## BOURNS

## **Product Change Notification**

Revised March 12, 2014

## Changes to Bourns® Model 1140 High Current Choke Series

Figure 2

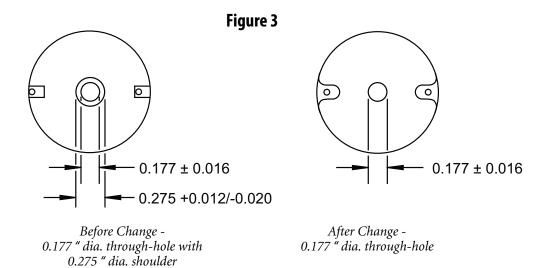
The <u>manufacturing location</u> is being transferred from Guangdong, China to Xiamen, China to help streamline the production process. To improve core production yield and reduce core chipping, the <u>core slot radius</u> has been increased (Figure 1). The <u>marking methods</u> have also been changed from an ink-marking to a more durable laser-marking (Figure 2). Another change is the addition of a <u>winding polarity mark</u>, which indicates the start lead of winding (Figure 2). The <u>Minimum Order Quantity (MOQ) / Multiples Quantity (Mult)</u> has changed from 240/24 to 140/70. <u>Rated current</u>, Idc, is redefined with Irms and Isat (Table 1). Lastly, the <u>center mounting hole diameter</u> has been modified (Figure 3).

Before Change - with Ink Marking

After Change - with Laser Marking and Polarity Mark
